DATE: 10/08/26
TO: All Bidders
FROM: David Cienfuegos, Purchasing Specialist
SUBJECT: Addendum 1 – Bid 739 Moorpark College Student Service Exterior Door Replacement

DRAWING changes and clarifications noted as Addendum 01 and dated 10/08/26

DOOR REPLACEMENT
STUDENT SERVICES (SS)
BUILDING

SITE PLAN

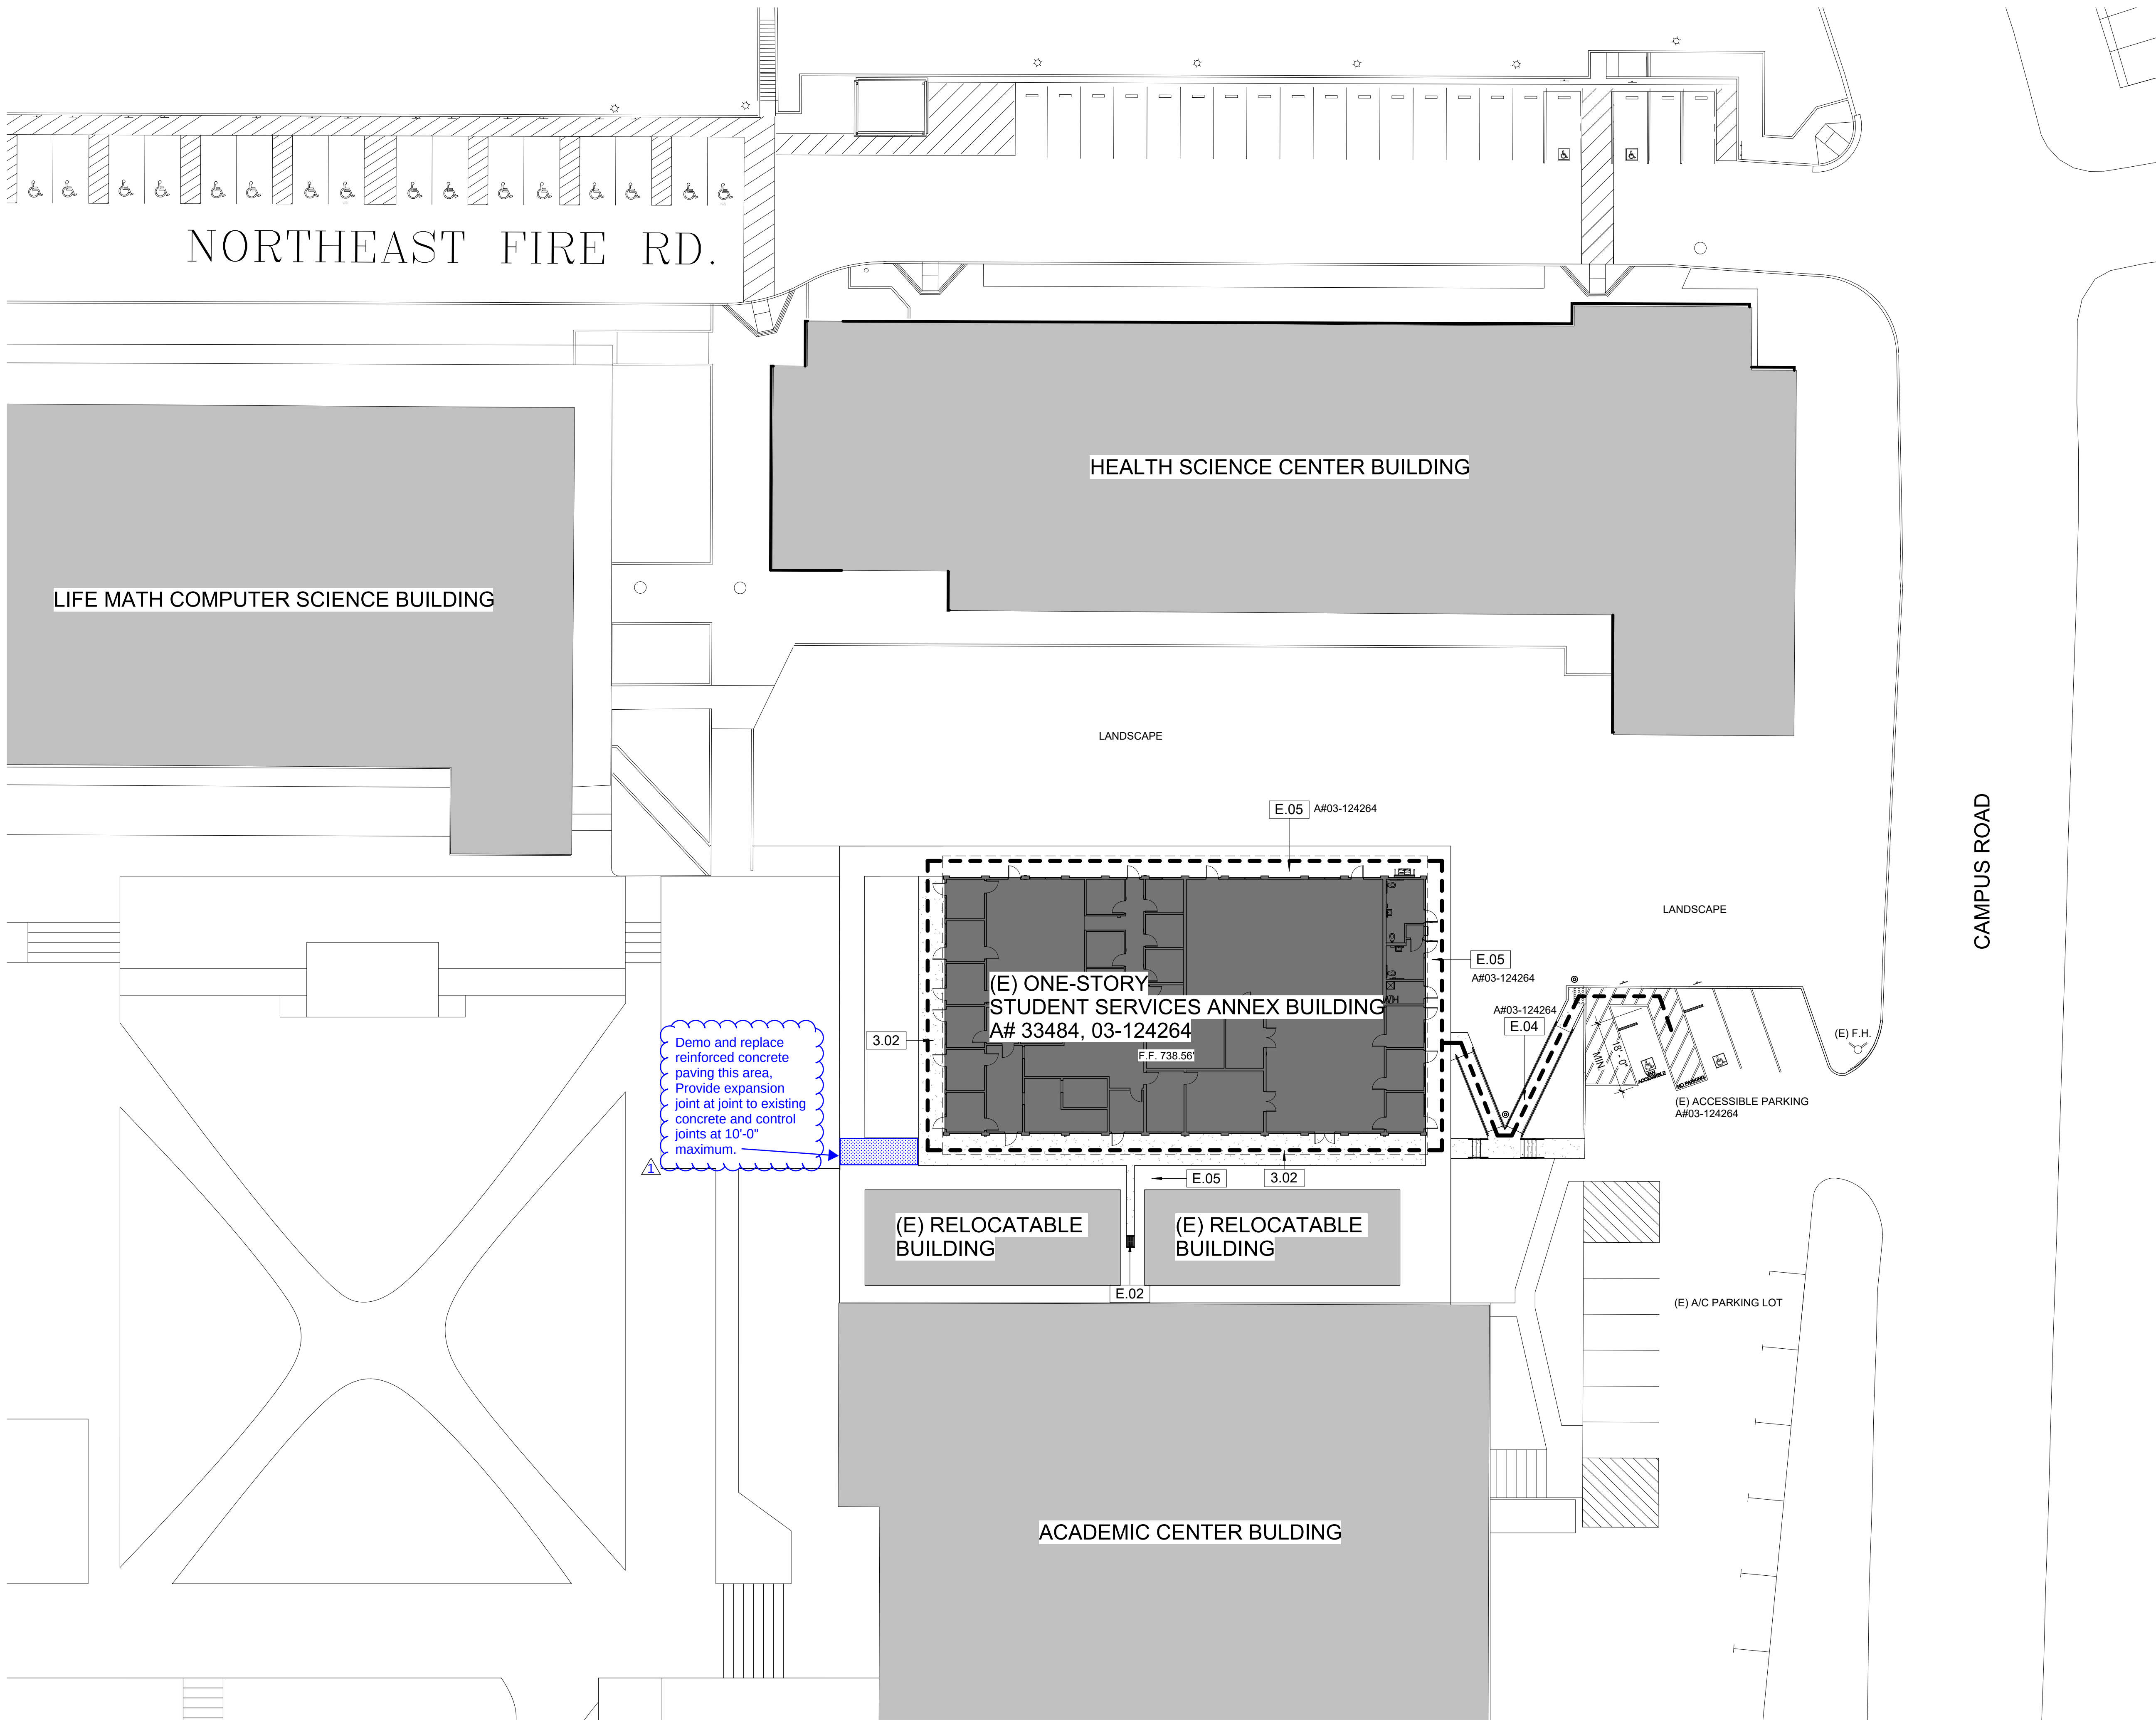
A102 – SITE PLAN: Add concrete pavement removal and replacement as noted

FLOOR PLAN

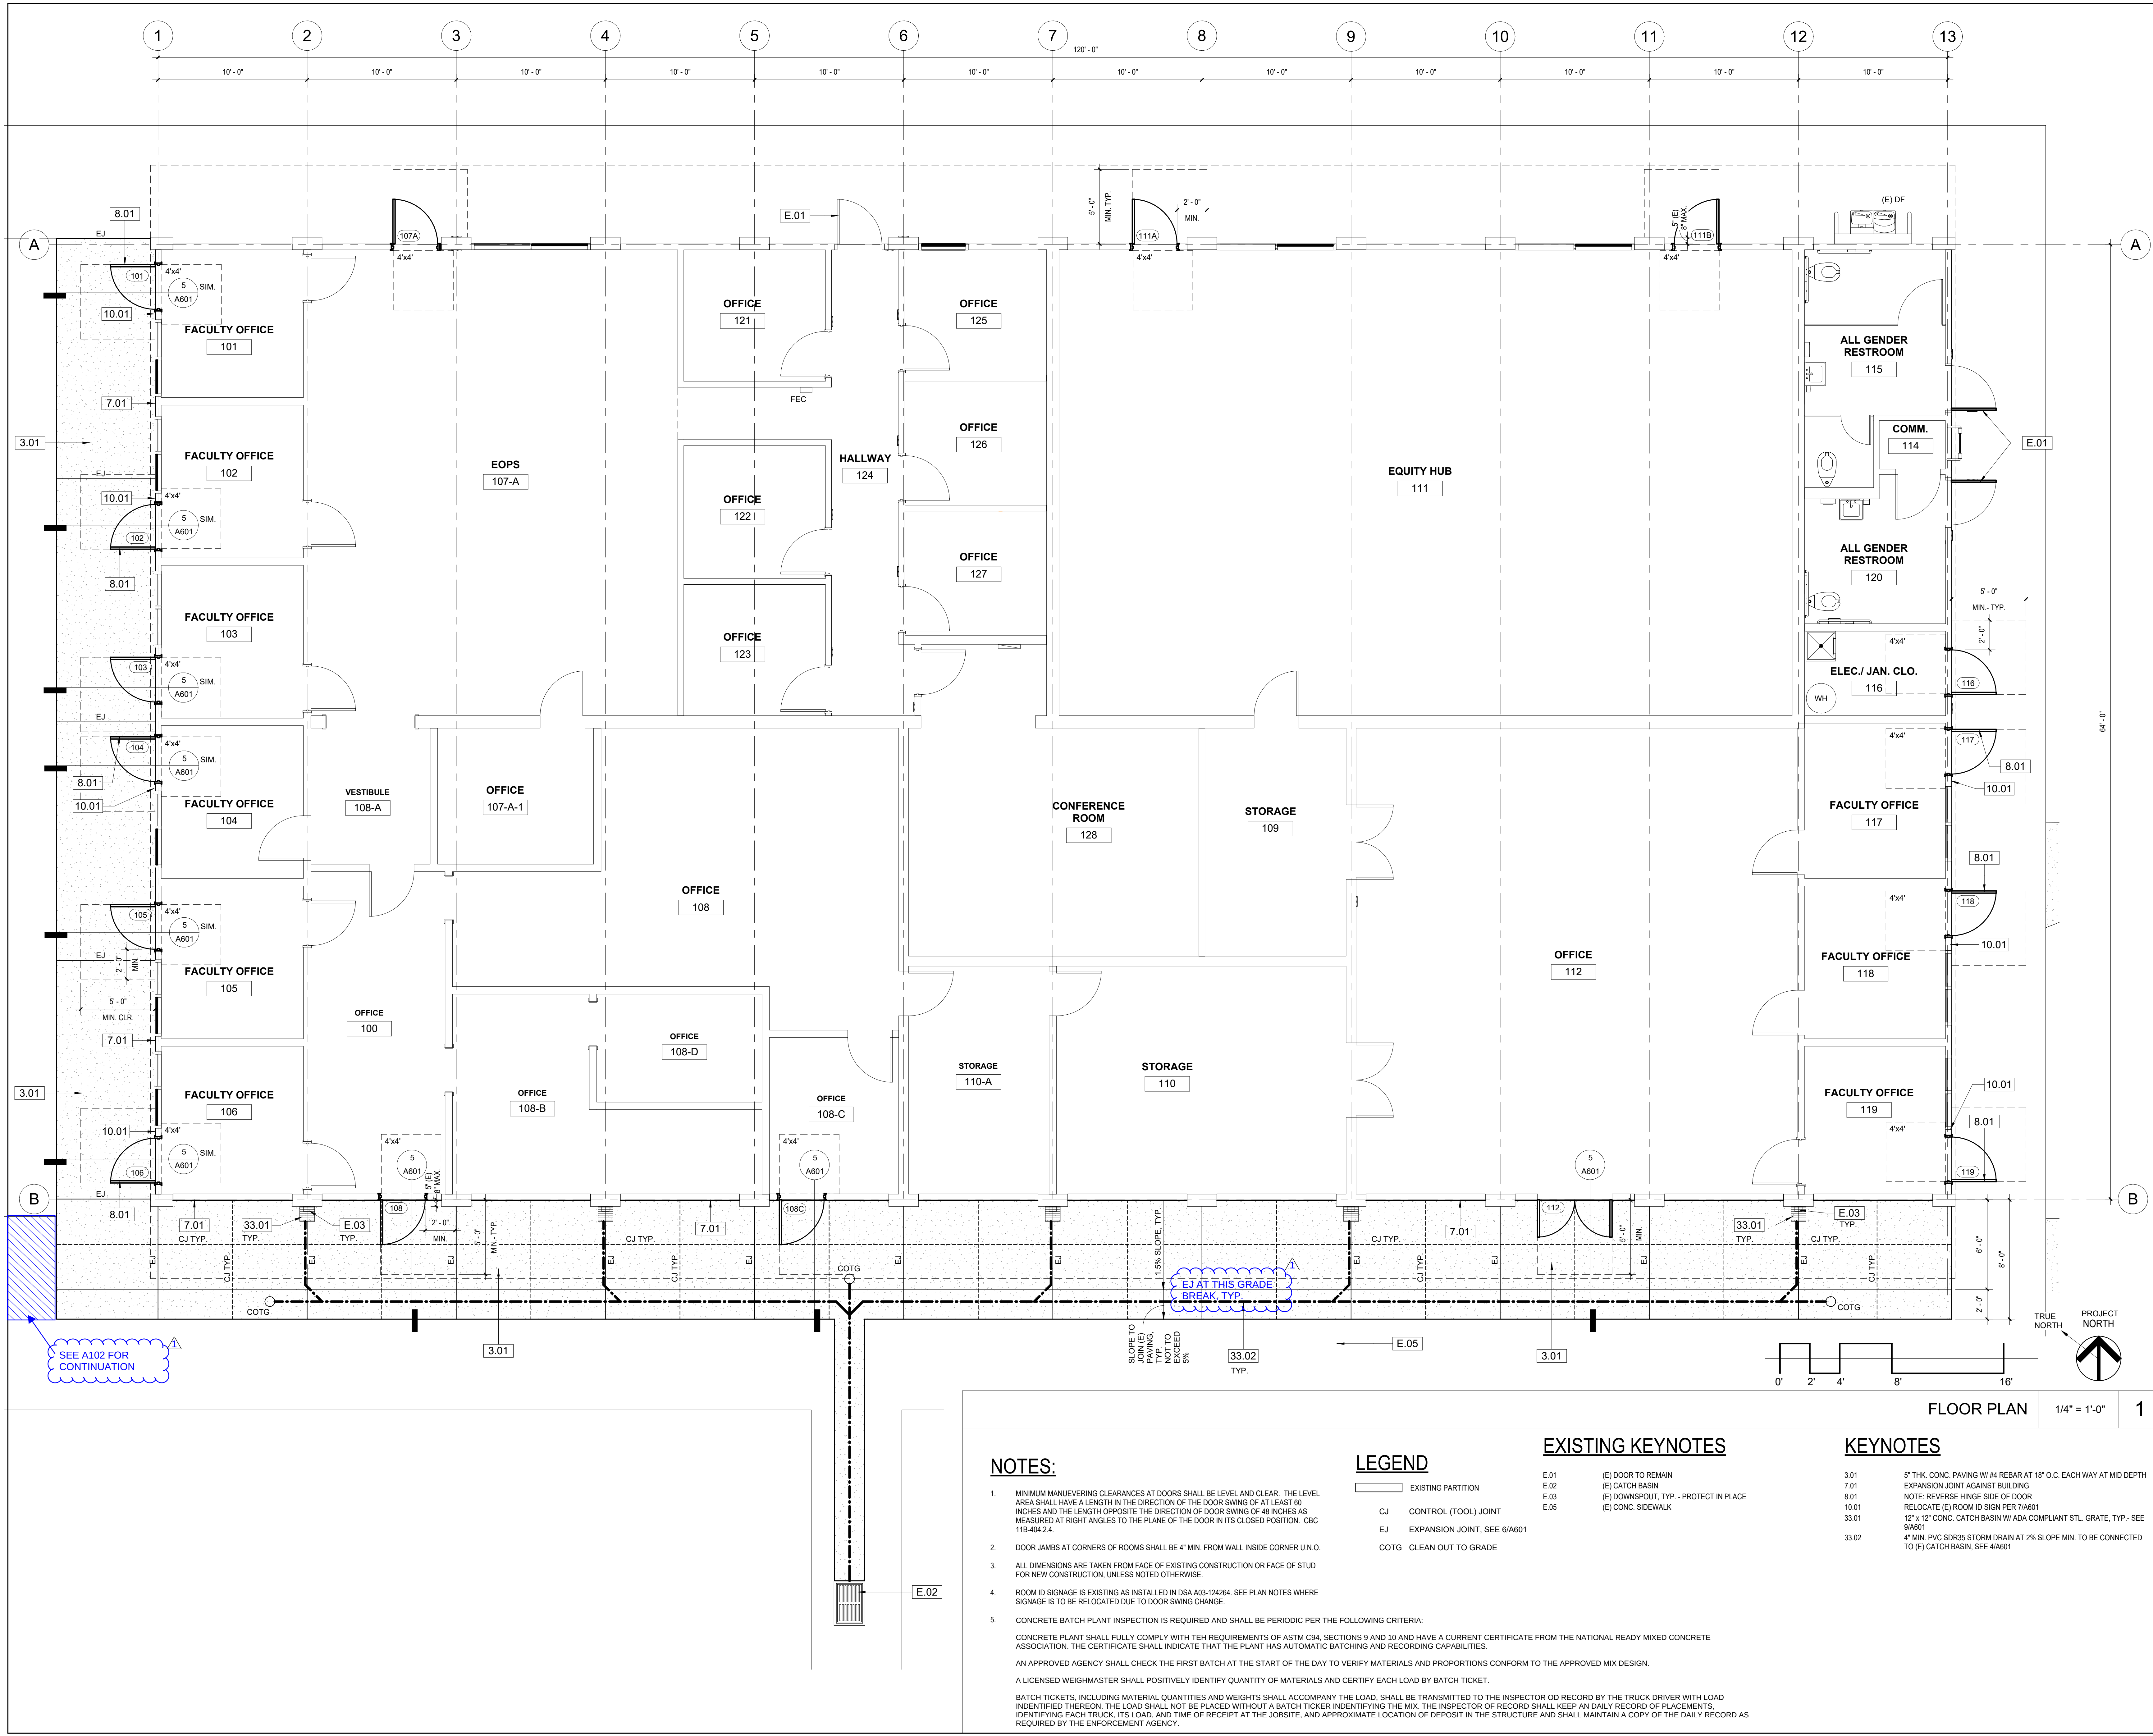
A106 – FLOORPLAN: Longitudinal Expansion Joint EJ noted on concrete paving. Additional concrete paving area referenced.
